# Response to Submissions Documentation

## Waterloo South

Stockland and Homes NSW

Revision B

Figure 6: Active Frontages

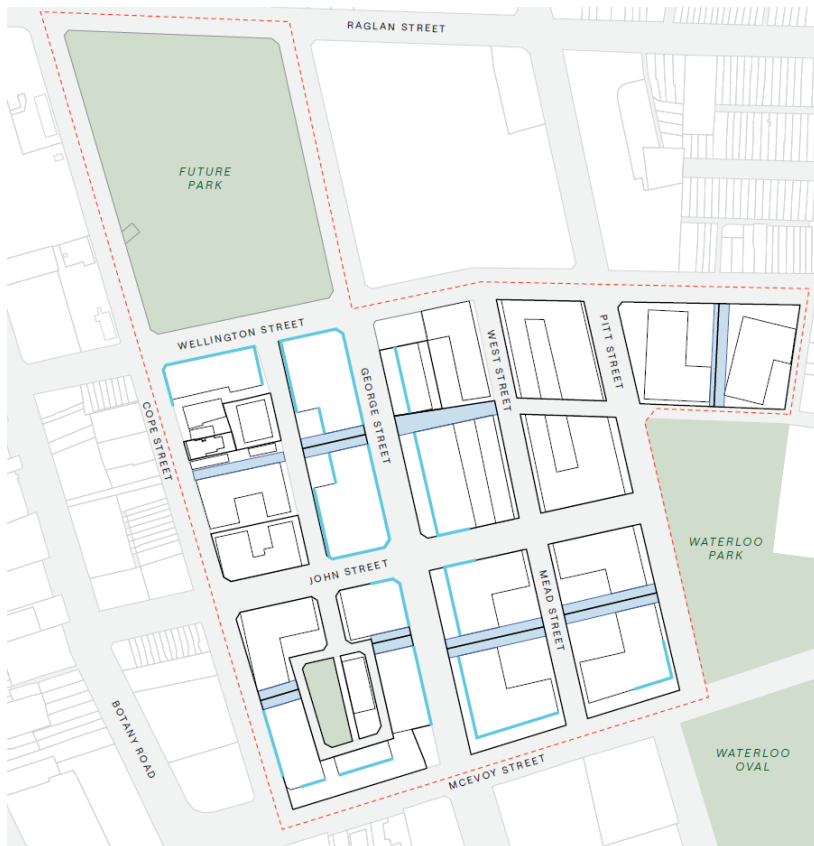
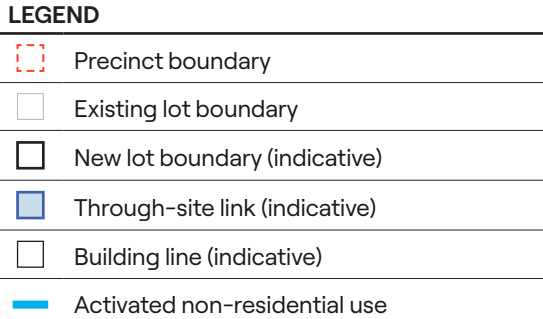
| Agency               |  | Summary of Key Issues                                                                                                                                                                                                                                                                                                                                                                                                                                                        | Response                                                                                                                                                                                                                                                                                                                                                                                                                                                                                                                                                                                                                                                                                                                                                                                                                                                                                                                                                                                                                                                                                                                                                                                                                                                                                                                                                                                                                                                                                                                                                                                                                                                                                                                                                                                                                                | Supporting RtS Documentation |
|----------------------|--|------------------------------------------------------------------------------------------------------------------------------------------------------------------------------------------------------------------------------------------------------------------------------------------------------------------------------------------------------------------------------------------------------------------------------------------------------------------------------|-----------------------------------------------------------------------------------------------------------------------------------------------------------------------------------------------------------------------------------------------------------------------------------------------------------------------------------------------------------------------------------------------------------------------------------------------------------------------------------------------------------------------------------------------------------------------------------------------------------------------------------------------------------------------------------------------------------------------------------------------------------------------------------------------------------------------------------------------------------------------------------------------------------------------------------------------------------------------------------------------------------------------------------------------------------------------------------------------------------------------------------------------------------------------------------------------------------------------------------------------------------------------------------------------------------------------------------------------------------------------------------------------------------------------------------------------------------------------------------------------------------------------------------------------------------------------------------------------------------------------------------------------------------------------------------------------------------------------------------------------------------------------------------------------------------------------------------------|------------------------------|
| Stockland            |  | <u>Active Frontages</u><br>Amend to align with Stage One design.                                                                                                                                                                                                                                                                                                                                                                                                             | Noted.                                                                                                                                                                                                                                                                                                                                                                                                                                                                                                                                                                                                                                                                                                                                                                                                                                                                                                                                                                                                                                                                                                                                                                                                                                                                                                                                                                                                                                                                                                                                                                                                                                                                                                                                                                                                                                  |                              |

Active frontages along McEvoy Street on Blocks 8 & 9 amended to reflect Stage One design.

Figure 18: Carpark Locations and Entries

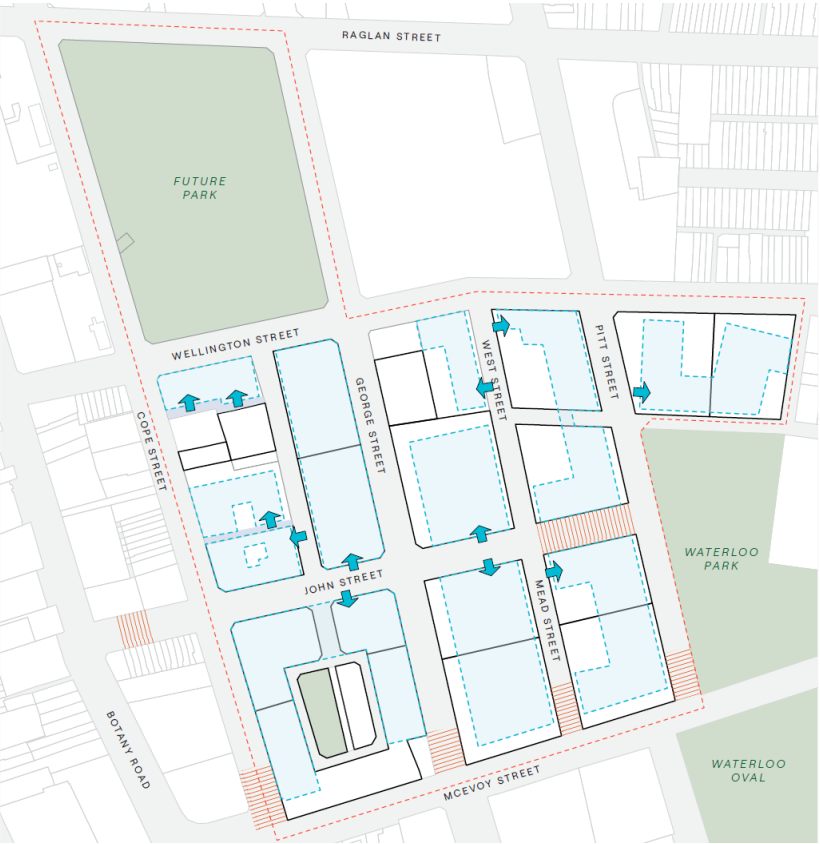
| Agency                   | Summary of Key Issues                                                                                                                                                                                                                                                                                                                                                                                                                                                                                                                                                                                                                                                                                                                                                                                                                        | Response                                                                                                                                                                                                                                                                                                                                                                                                                                                                                                                                                                                                                                                                                                                                                   | Supporting RtS Documentation |
|--------------------------|----------------------------------------------------------------------------------------------------------------------------------------------------------------------------------------------------------------------------------------------------------------------------------------------------------------------------------------------------------------------------------------------------------------------------------------------------------------------------------------------------------------------------------------------------------------------------------------------------------------------------------------------------------------------------------------------------------------------------------------------------------------------------------------------------------------------------------------------|------------------------------------------------------------------------------------------------------------------------------------------------------------------------------------------------------------------------------------------------------------------------------------------------------------------------------------------------------------------------------------------------------------------------------------------------------------------------------------------------------------------------------------------------------------------------------------------------------------------------------------------------------------------------------------------------------------------------------------------------------------|------------------------------|
| City of Sydney Community | <u>Vehicle Access Locations</u><br>There are some inconsistencies between the submitted Transport Study and the Design Guide. The Transport Study does not show a vehicle access into Block 4A from West St, while the latter does. Additionally, the Transport Study does not show access into 2A, 2B or 2E, while Design Guide shows two access points. This should be clarified in documentation                                                                                                                                                                                                                                                                                                                                                                                                                                          | <a href="#">Car park entries servicing the private lots within Blocks 4A, 2A and 2E have been removed from the amended Design Guide map. PTC will update the Transport Study to illustrate an indicative 6m-wide access arrangement to Block 2B from Cooper Street. As no basement is proposed for Block 2B, a vehicle entry is not required.</a><br><br><a href="#">The Block 8 basement footprint has also been revised to align with the Stage 1 design. The basement is now configured as two separate structures, connected via a services tunnel beneath Cooper Street. An additional car park entry providing access into 8BB1 will be added in the Design Guide.</a>                                                                               |                              |

Car park entries servicing the private lots within Blocks 4A, 2A and 2E have been removed from the amended Design Guide map. PTC has updated the Transport Study to illustrate an indicative 6m-wide access arrangement to Block 2B from Cooper Street. As no basement is proposed for Block 2B, a vehicle entry is not required.

The Block 8 basement footprint has also been revised to align with the Stage 1 design. The basement is now configured as two separate structures, connected via a services tunnel beneath Cooper Street. An additional access to 2D from Cooper Street and 8BB1 from John Street has been added.
